County of Fairfax, Virginia

Re: RZ/FDP 2005-SP-019, Ridgewood, (Tax Map 56-2 ((1)) 37): Site Modifications

RE: Proffer Interpretation for Rezoning RZ 2005-SP-019

INTERPRETATION PLAN

CONCEPTUAL GARAGE
COURTYARD ELEVATION

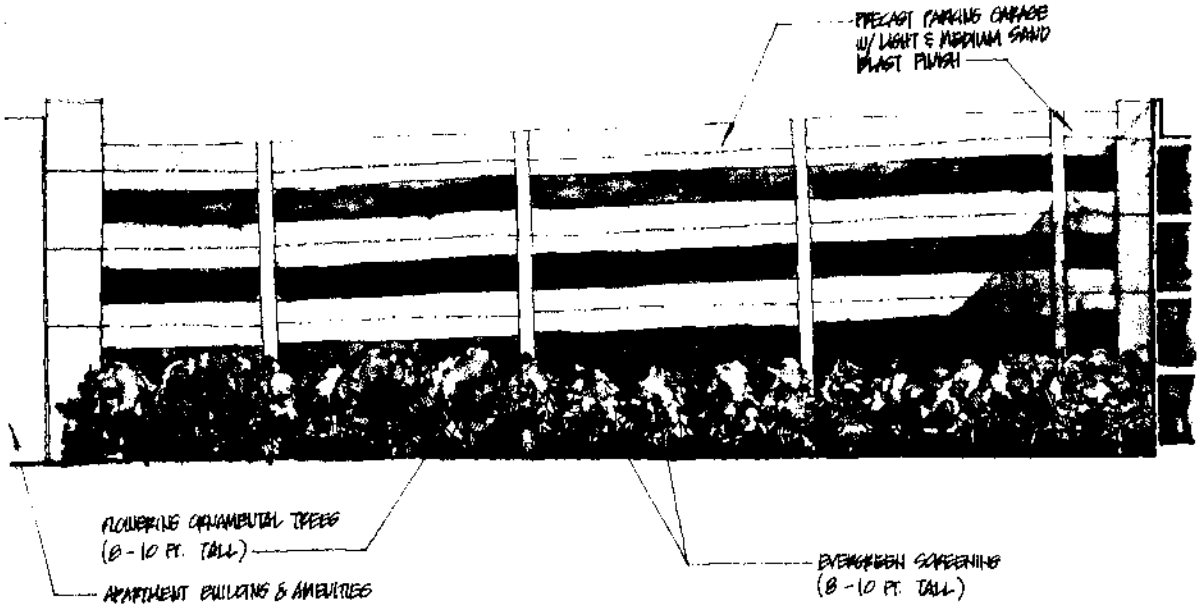
This is a follow-up to my earlier letters on the same subject. In our most recent conversation, you have asked for some additional information about the architectural and design treatment of the portions of the parking garage that are visible within the interior courtyards associated with "Building 3".

To that end, attached is a sketch showing design commitments that reflect this objective. Their comments go well beyond the obligations of the proffers. The proposed design incorporates an aggressive landscaping proposal at ground level. In fact, proposed trees closest to the garage will be 8-10" in height at the time of planting. In addition, the Applicant has committed to design the visible portions of the garage with a color and texture of materials that is complimentary to the building facade.

1 RIDGE TOP ROAD AND GOV. CENTER PKWY. PLAZAS
1"=20'

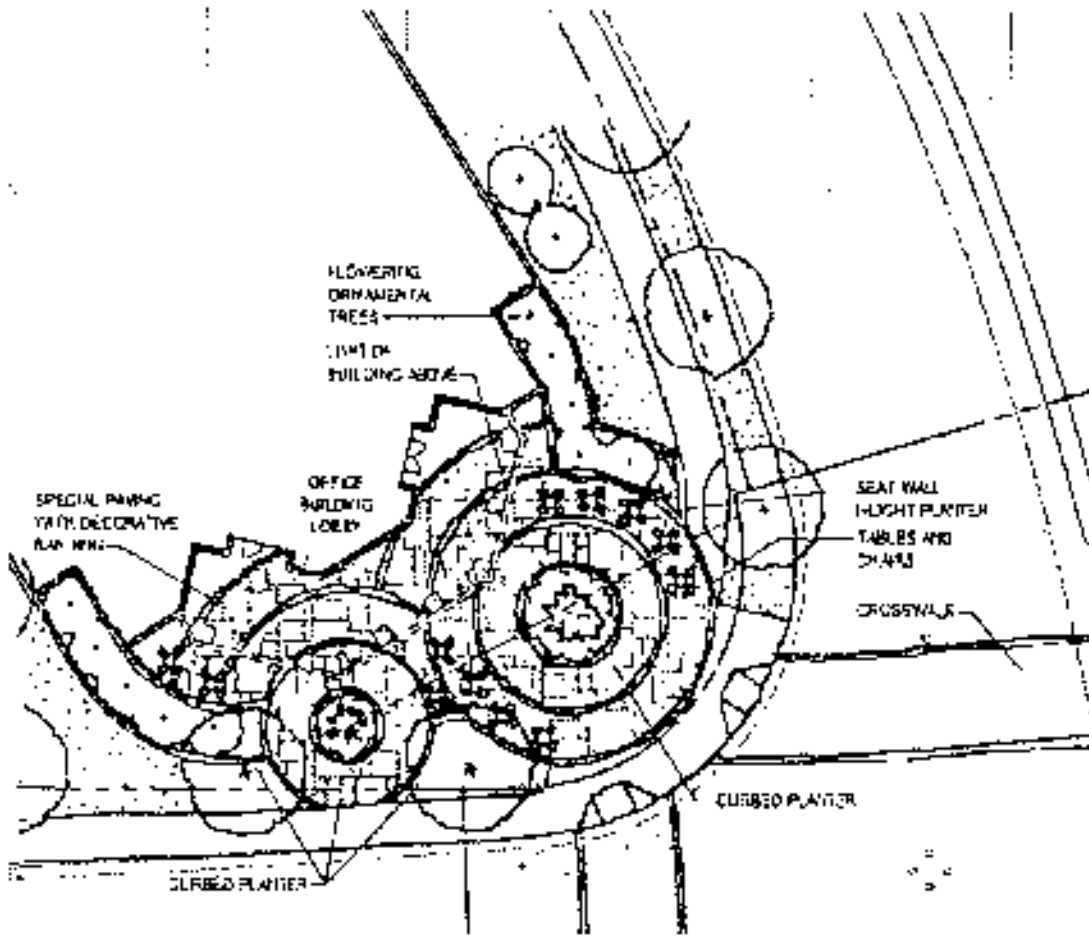
In our discussions, staff had requested that the plazas shown on the Interpretation Plan at: (1) Ridge Top Road and Government Center Parkway Extended; and (2) the southeast corner of Building 2.2 be redesigned to better reflect the approved CDP/FDP. The revised Interpretation Plan restores the plaza at Government Center Parkway Extended and Ridge Top Road to a size, shape and configuration that is identical to that reflected on the CDP/FDP.

4 BUILDING 3 COURTYARD
1"=20'

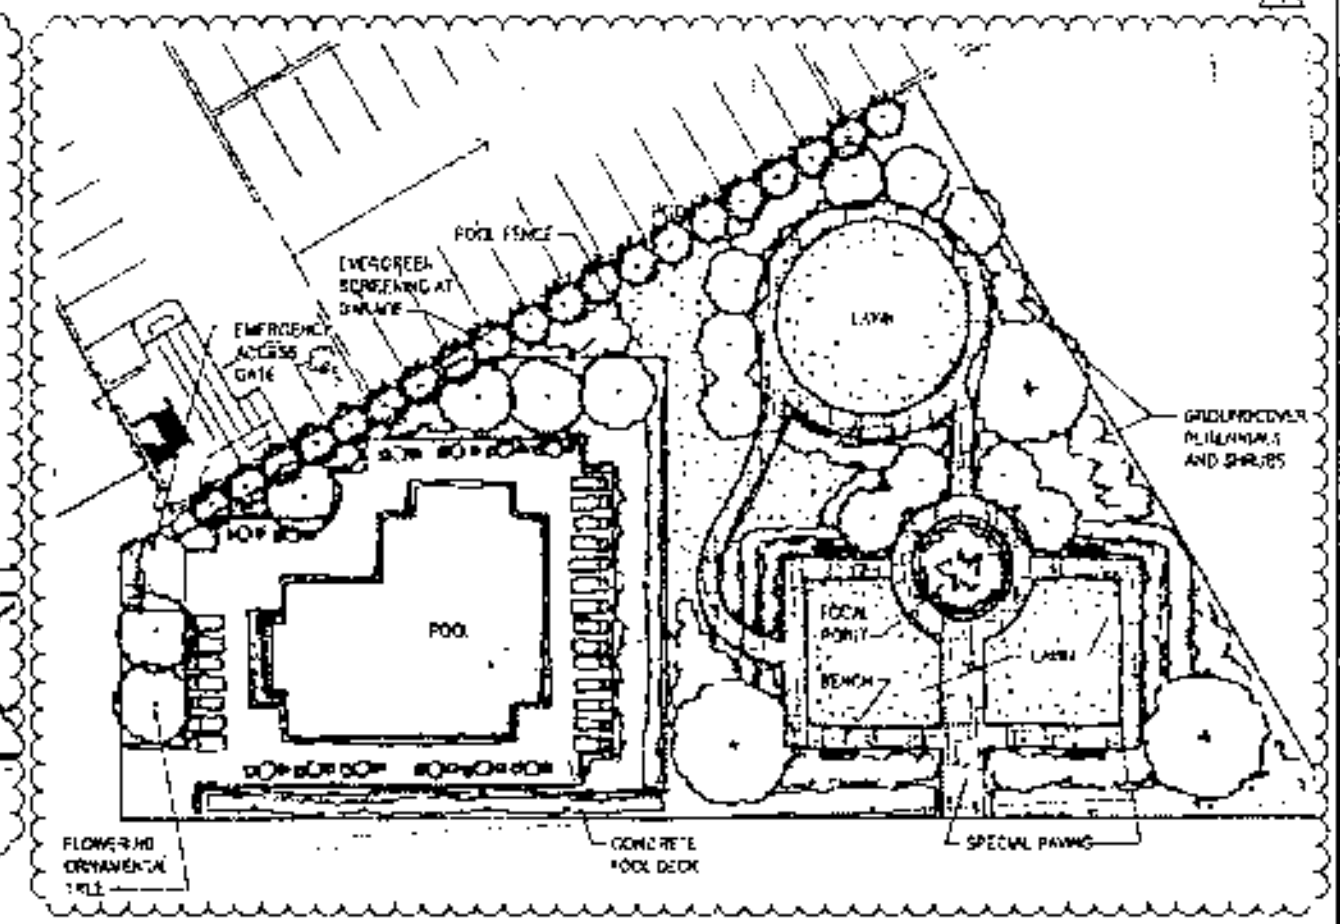
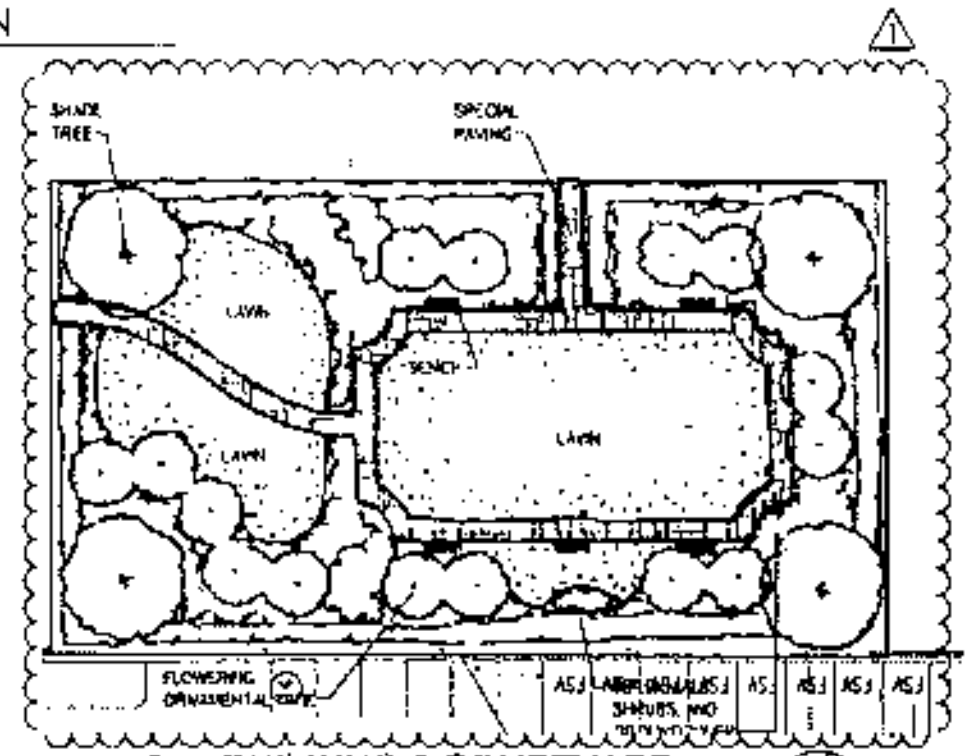
Staff had also asked for reconfirmation that the reconfigured interior plaza courtyard for Building 3 did not diminish exposure of these areas to natural light when compared to that shown on CDP/FDP. Obviously, the proposed minor modification

creates considerably more usable interior recreation space. As to the question asked, there is no diminishment of available natural light. When compared to the governing CDP/FDP, building heights and configurations are not dramatically changed from the governing CDP/FDP. In fact, if anything, the interpretation plans strategically relocates the swimming pool to an area that has even greater exposure to sunlight. Similarly, as further evidence of the visibility of this area, the developer also contemplates the installation of an internal balcony to give residents further access to this area. For ease of reference, I have attached the shadow studies (Exhibit 6) conducted as part of the rezoning approval. Again, given that the height and configuration of the building is not changing in the relevant areas, these studies remain effective in terms of evaluating the presence of natural light.

DRAWING TITLE
CONCEPTUAL GARAGE ENTRY ELEVATION

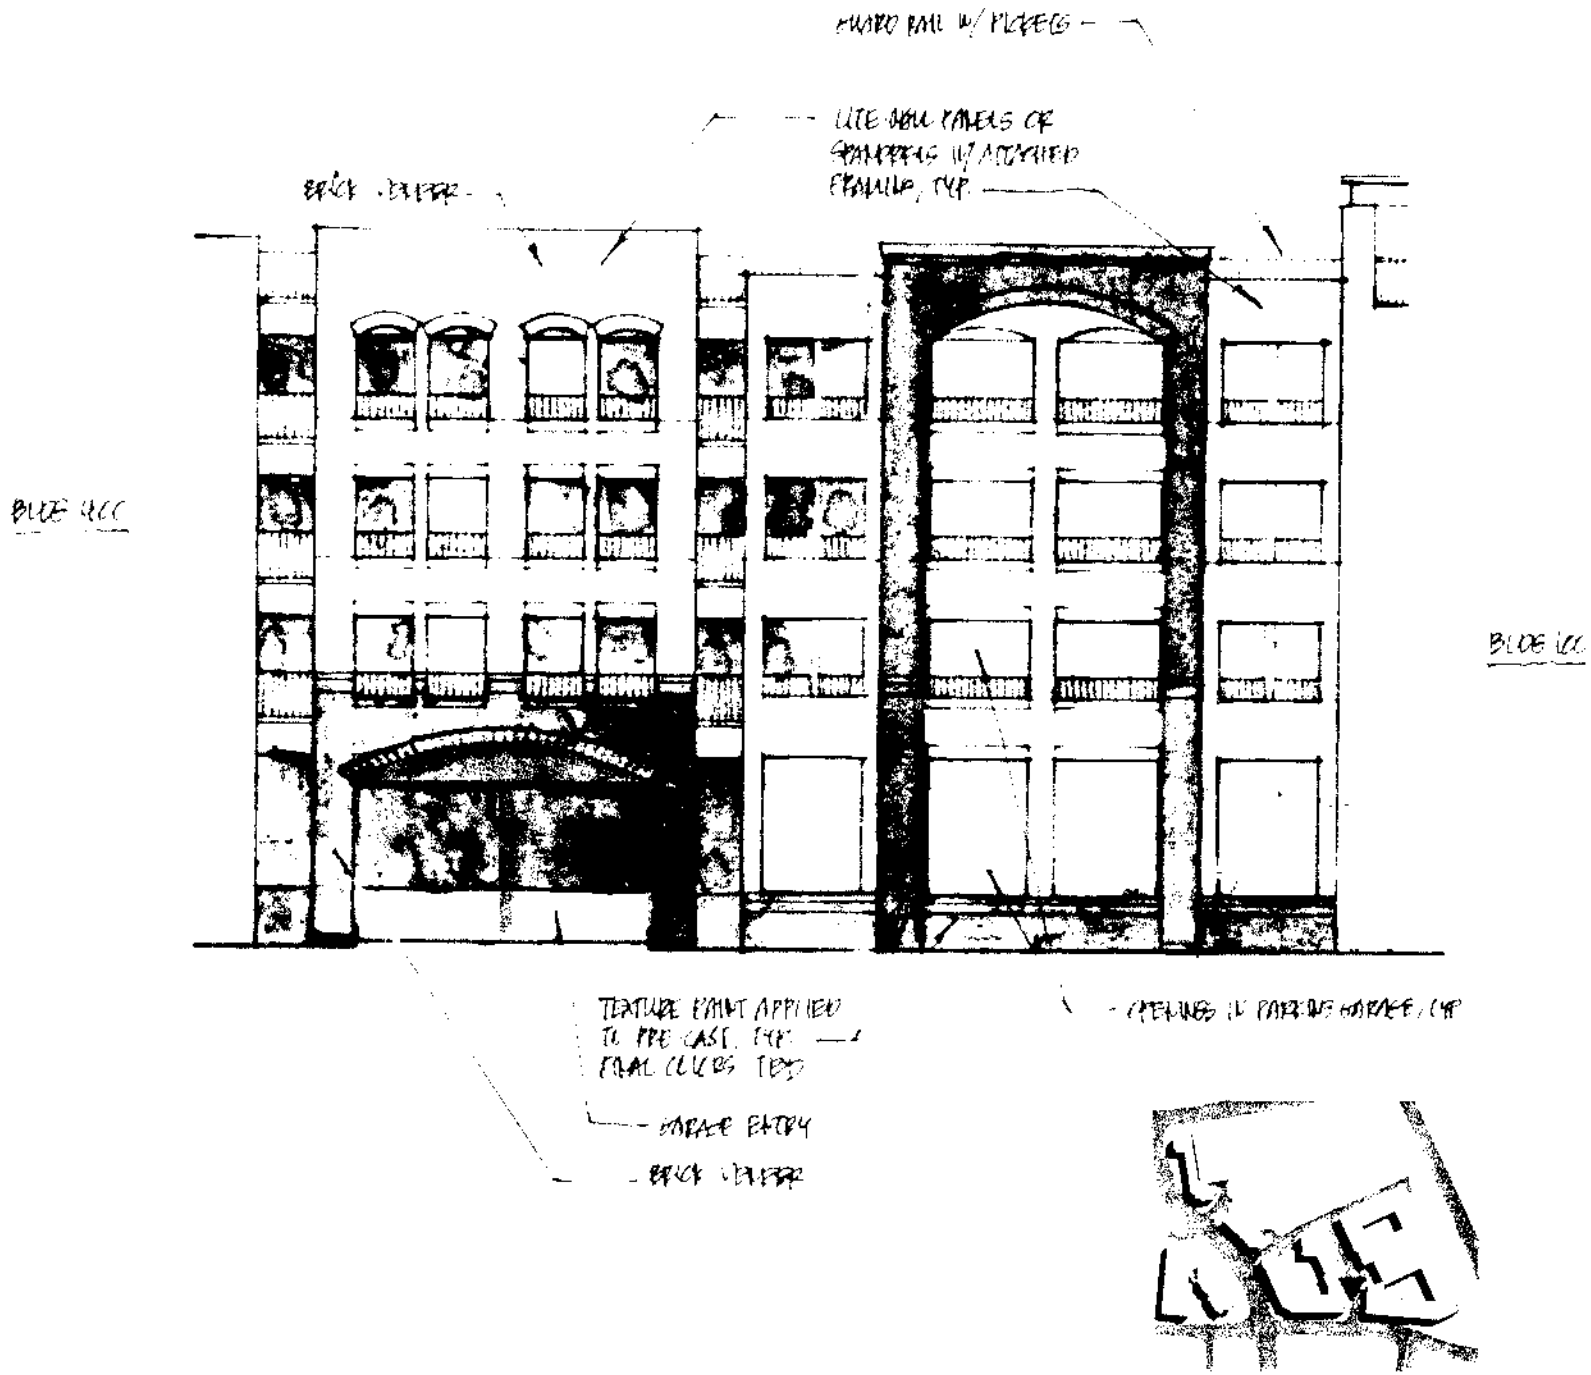
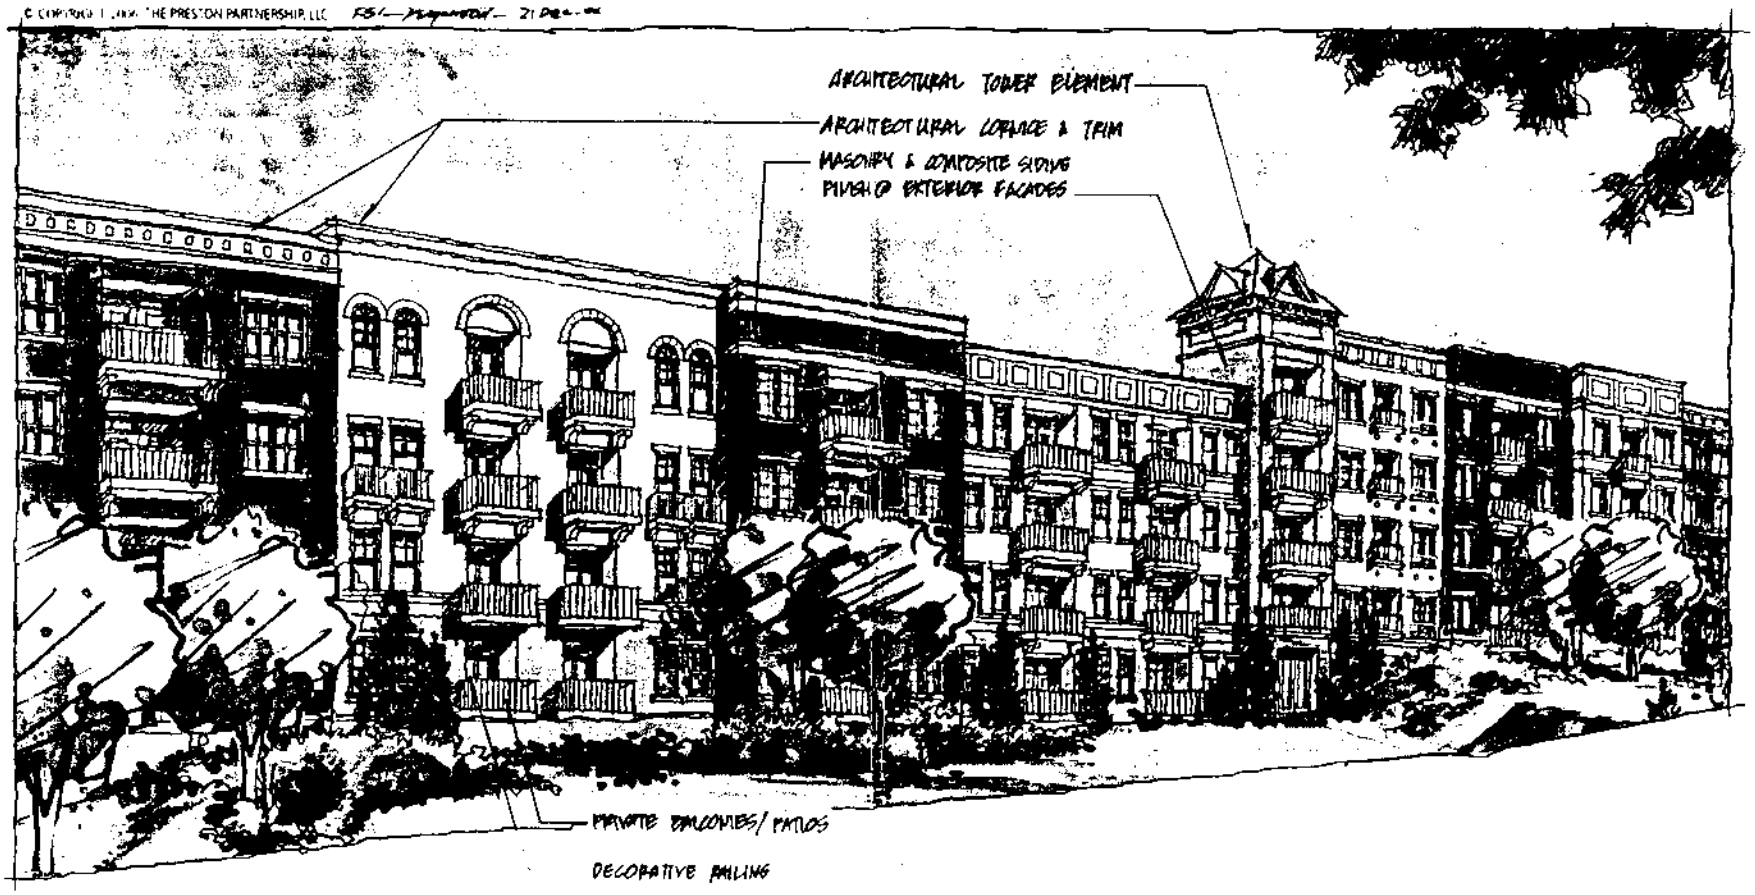
Staff had requested additional design detail regarding the appearance of the parking garage entrance now proposed from the internal east-west roadway. Exhibit 4 contains a detailed rendering that shows the articulation, the design theme and building materials associated with this area of the property. As the Exhibit shows, the developer has gone to great lengths to make the entrance for the garage fully integrated, with the overall architectural scheme. This is a level of design detail well above the minimum requirements of the proffered conditions. As alluded to in our original interpretation request, the practical effect of this minor relocation of the garage entrance is to eliminate a large portion of the exposed parking garage that would have been visible from future development plan on the abutting property to the east.
